SCSI cable media performance working group (SCMP)  
October 26-27, 1999  
Huntington Beach, CA

Subject: Draft minutes for the SCSI cable media performance working group CMP

Comments against SPI-3 rev 10

**TEST FIXTURE / MEASUREMENT PROCESS IS CALIBRATED  
TO REPORT AT TP1**

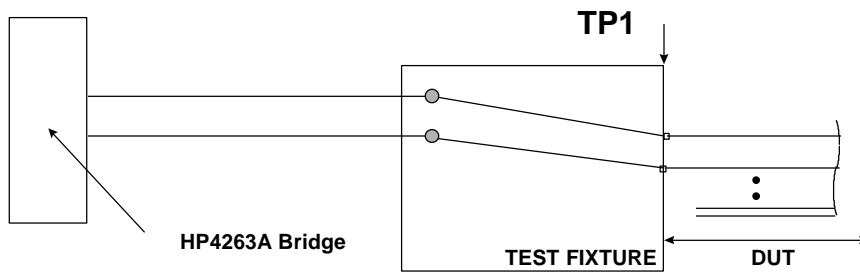
30. technical

In section E.3.1.2

change: See E.2.2.2 for appropriate test fixtures.

To: Figure x shows the configuration to use for this measurement procedure.

Add the following figure x describing the test fixture to section E.3.1.2 with the title "Test fixture for single ended capacitance measurement".

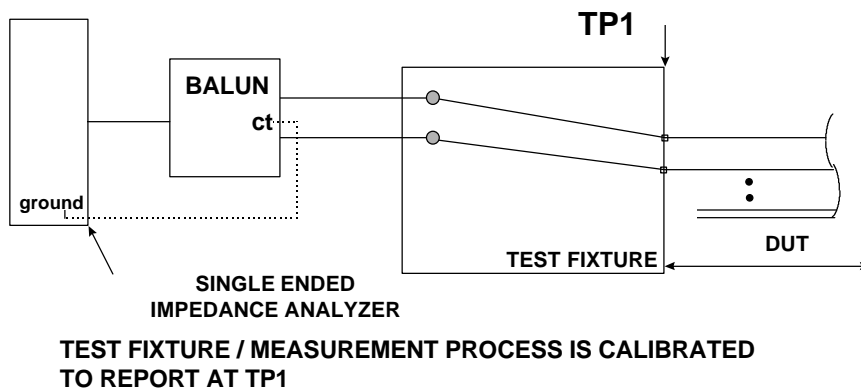
36. technical

In section E.3.2.2

Change:

See E.2.2.2 for appropriate test fixtures.

To:

Refer to Figure x for the proper test configuration.  
[Add a new Figure x shown below titled "Test fixture for differential capacitance measurements"].

**TEST FIXTURE TO MEASURE PROPAGATION TIME**

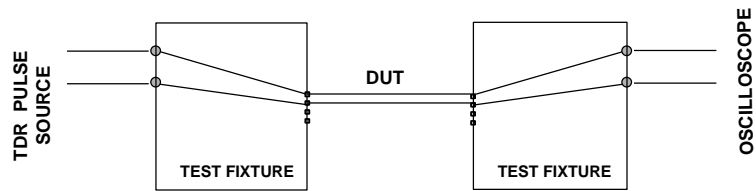
46. technical

In section E.5.2 change:

See E.2.2.2 for appropriate test fixtures.

To: See Figure x for appropriate test fixture.

Add new figure x given below showing the test fixture with the title "Propagation time measurement setup".

**TEST FIXTURE / MEASUREMENT PROCESS IS CALIBRATED TO REPORT AT TP1**

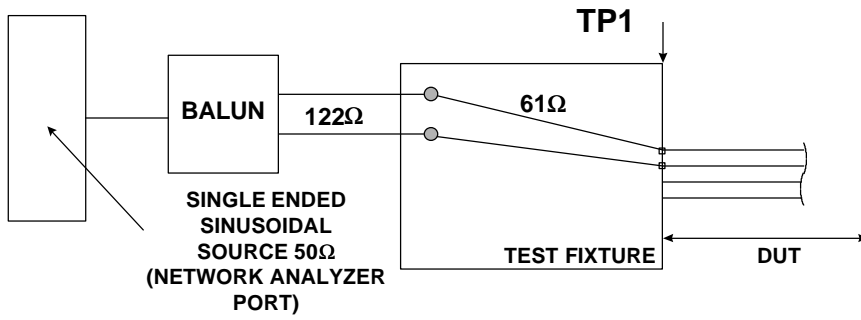
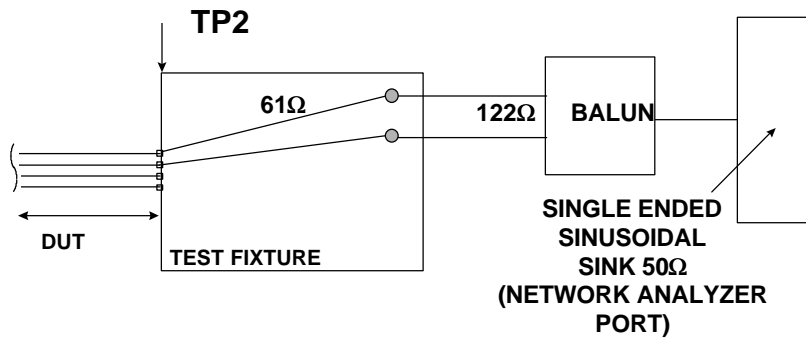
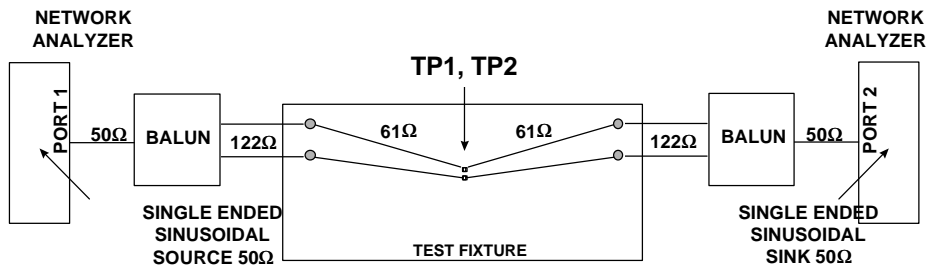
56. technical

In section E.7.1.1 replace Figures E.12, E.13, and E.14 with the following respective figures: (same figure titles)

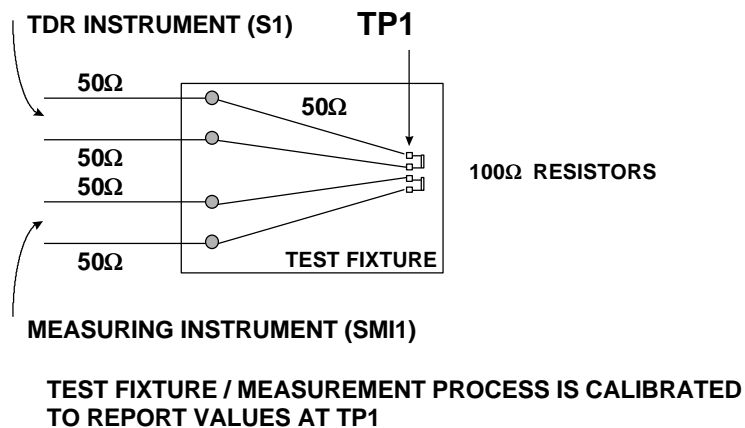
62. technical

In section E.8.3 change Figure E.17 to:

**TEST FIXTURE / MEASUREMENT PROCESS IS CALIBRATED  
TO REPORT VALUES AT TP1**

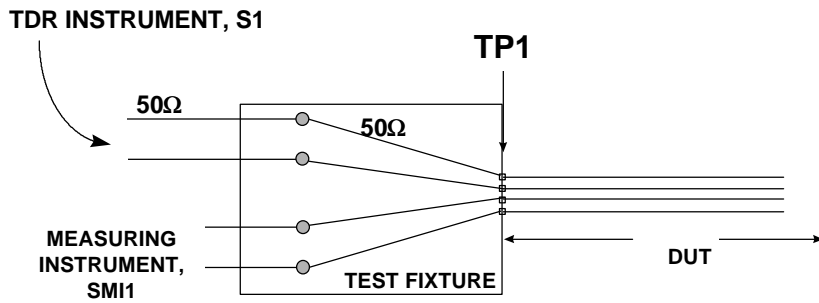
64. technical

In E.8.4 change: Figure E.18 to:
